In re U.S. Patent No.: 7,517,387 B2 )  
Inventors: Jacques CHEVALLET et al. )  
Issue Date.: April 14, 2009 )  
For: GAS SEPARATION DEVICES )

**REQUEST FOR RECONSIDERATION OF REQUEST FOR  
CERTIFICATE OF CORRECTION**

In re Application of:	)	
	)	
Nicolas SEMENZATO et al.	)	Group Art Unit: 1797
	)	
Application No.: 10/518,787	)	Examiner: Douglas J. THEISEN
	)	
Filed: December 21, 2004	)	
	)	
For: GAS SEPARATION DEVICES	)	Confirmation No.: 8238
	)

**REPLY TO OFFICE ACTION**

Fig. 6

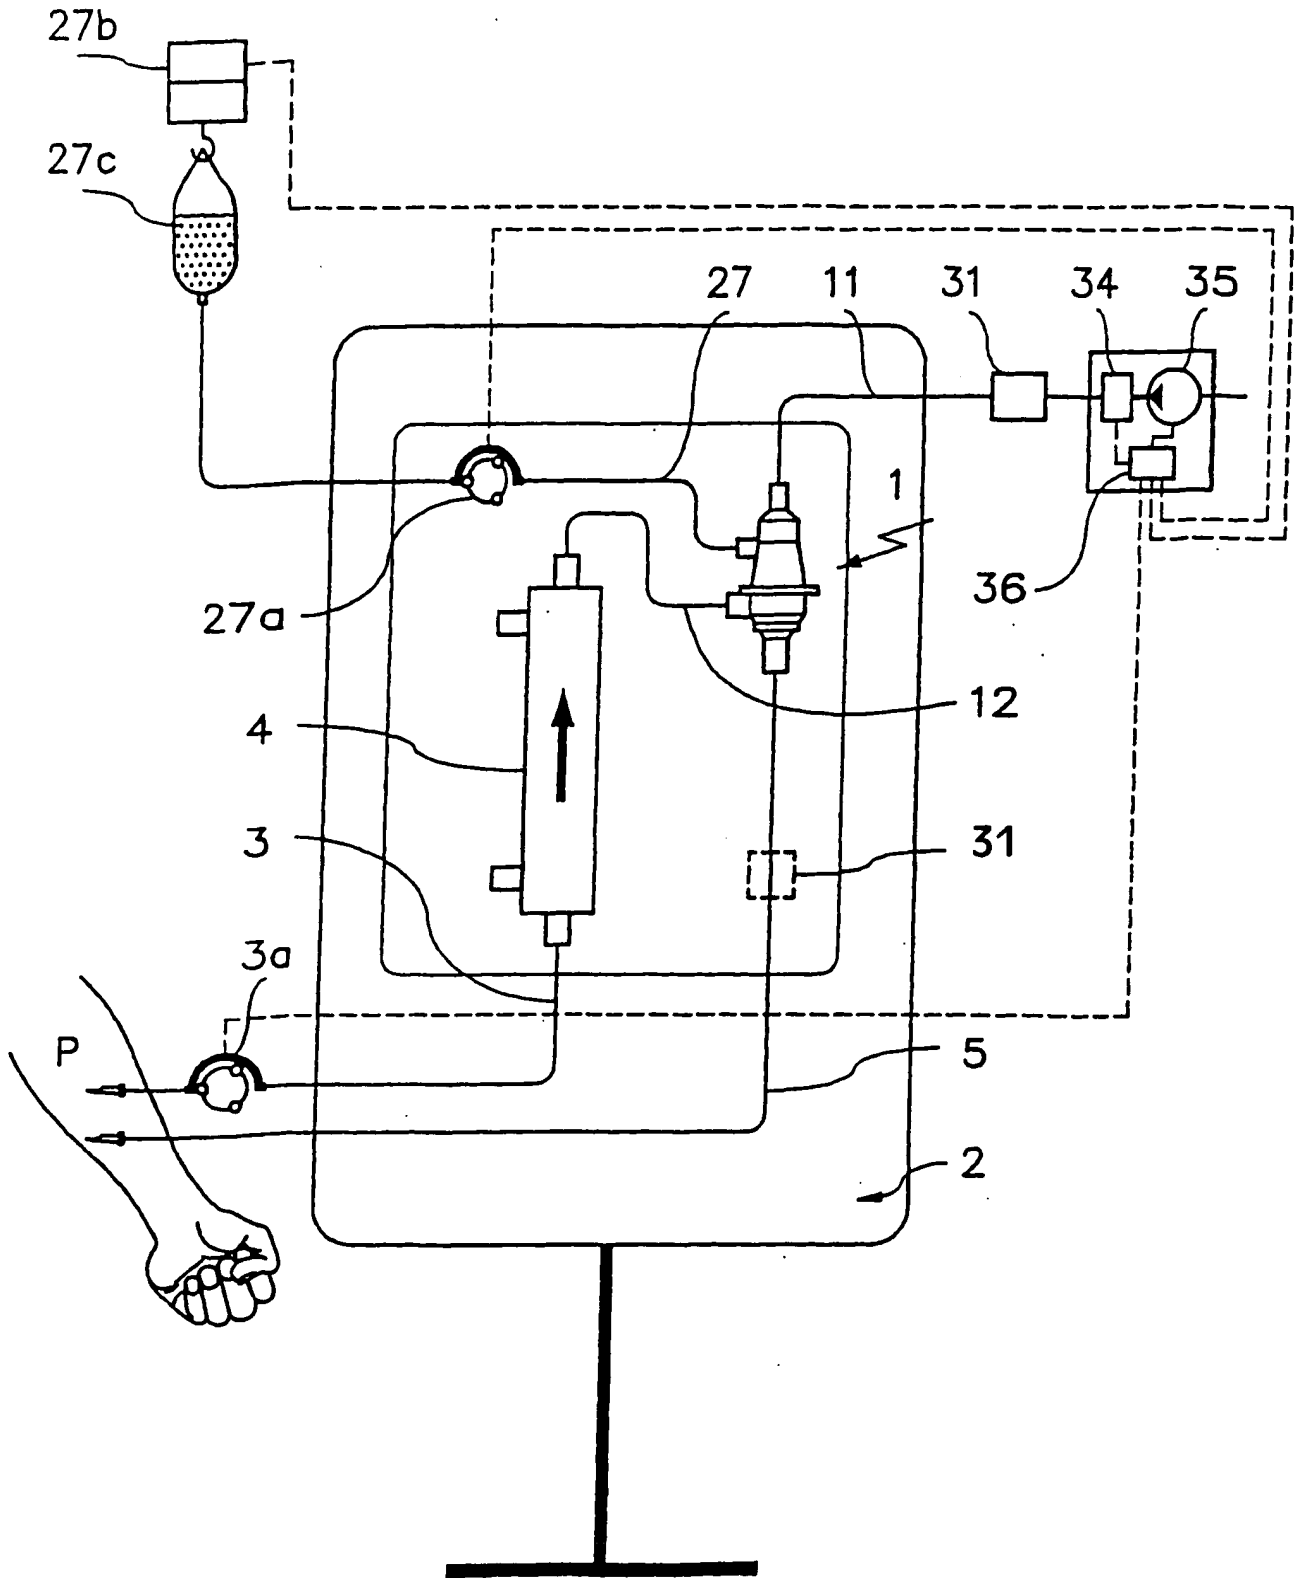
The attached replacement sheet of drawings 3/3 includes changes to Fig. 6. In Fig. 6, on branch 5 below device 1, reference numeral 34 has been replaced with reference numeral 31, which properly corresponds to the pressure sensor element positioned on branch 5.

The Examiner objected to the drawings for "failing to comply with 37 CFR 1.84(p)(4) because reference character '34' has been used to designate both 'solenoid valve' and something in return branch 5 of fig. 6." (Office Action at 2.) In this Reply, Applicant has provided a Replacement Sheet 3/3, which includes a replacement of Fig. 6. In this replacement sheet, reference number 34 on branch 5 below device 1 has been replaced with reference numeral 31. Accordingly, new reference numeral 31 now properly corresponds to the pressure sensor element located on branch 5. Applicant points out, however, that Replacement Sheet 3/3 contains two pressure sensor elements having reference numeral 31. As described in the specification, the pressure sensor element 31 may be positioned on line 11 next to solenoid 34, or may alternatively be positioned on branch 5 below device 1, as depicted by the dashed-line block on Replacement Sheet 3/3. Thus, based on this explanation and the revision to Fig. 6 discussed above, Applicant respectfully asks the Examiner to withdraw the objection to the drawings.

As an alternative to what is described above, the pressure sensor element ~~34~~ 31  
can be made to operate down-line from the device 1.
